## DEVELOPMENT BOARD

ECE3301L SESSION 3  
LAB 11

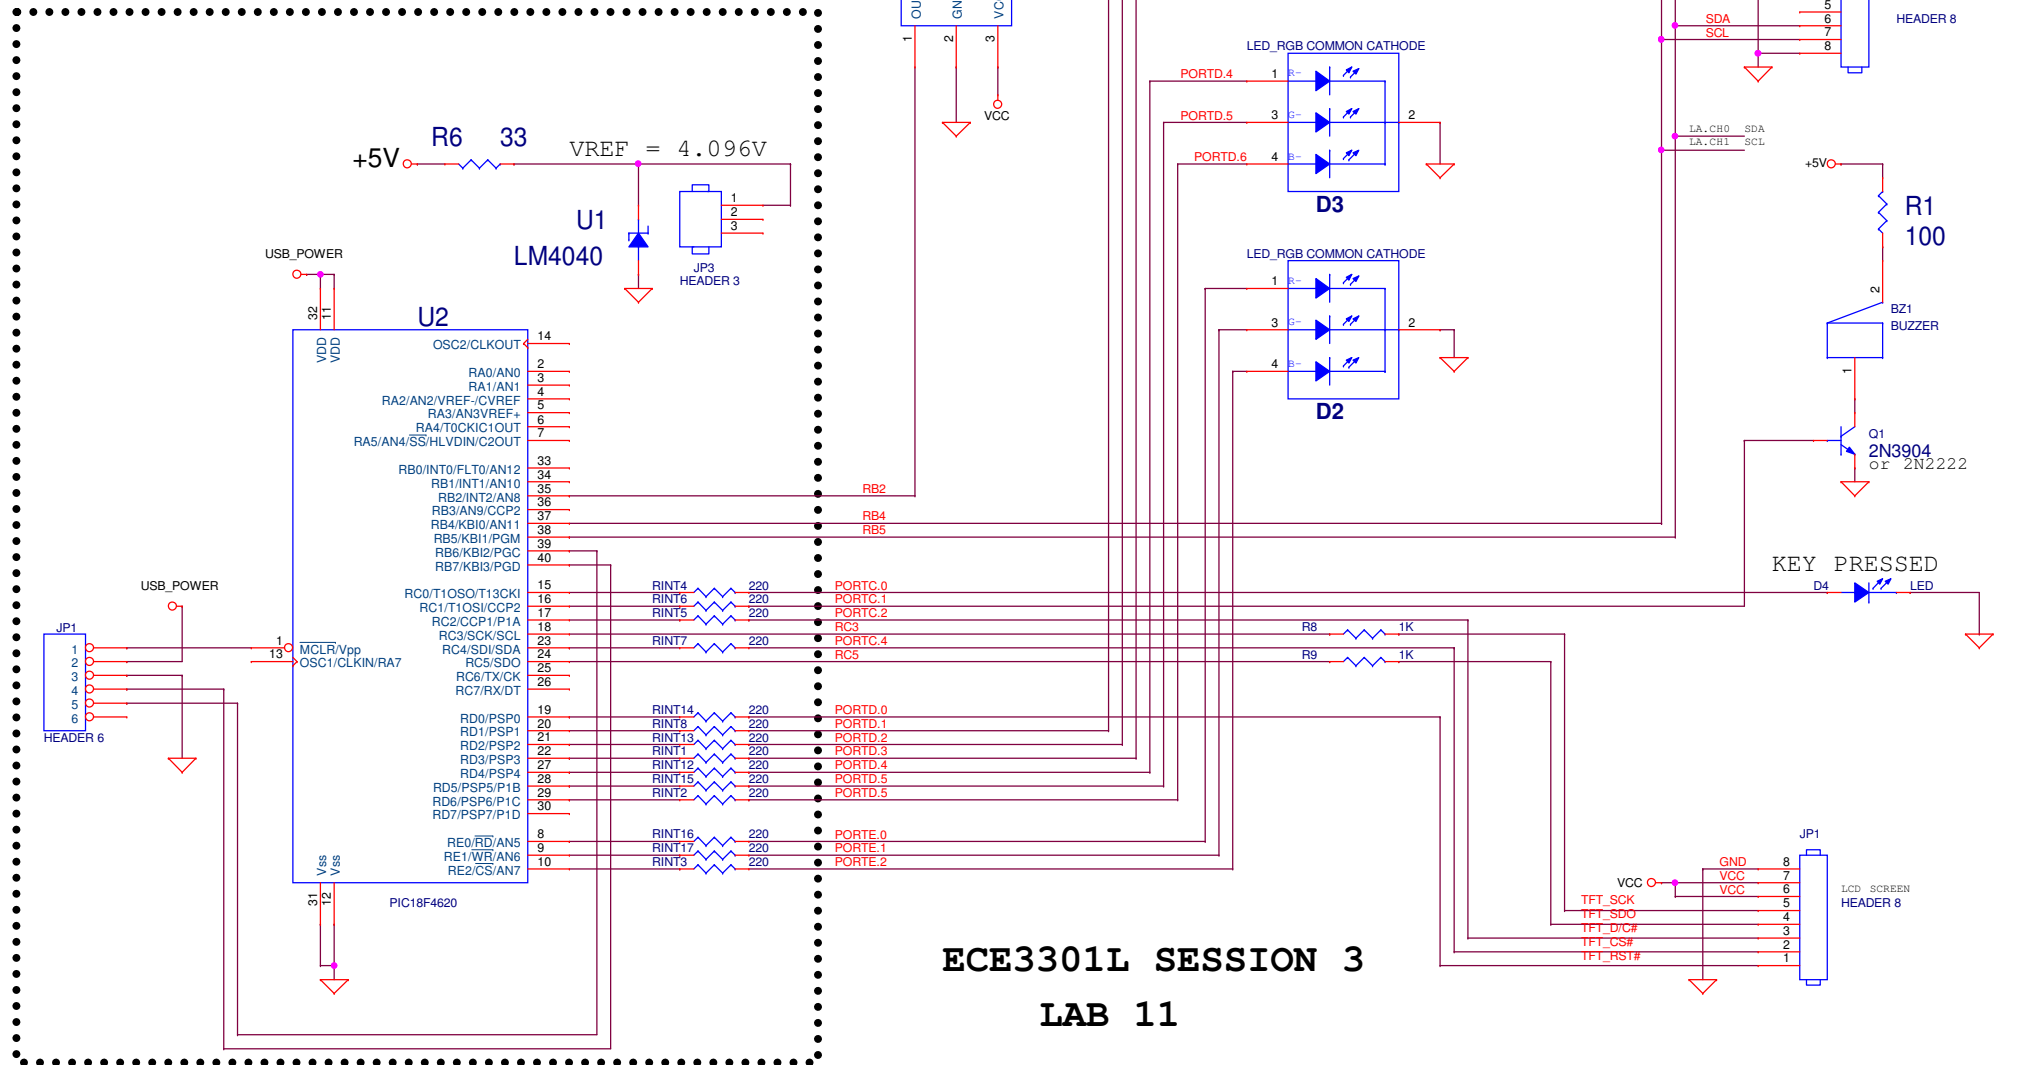
REMOVE THE JUMPER AT JP3 THAT IS CONNECTING PIN 1 TO 2 AND MOVE IT TO CONNECT FROM PIN 2 TO PIN 3. THIS WILL ALLOW THE SIGNAL 'RA3' TO WORK PROPERLY.
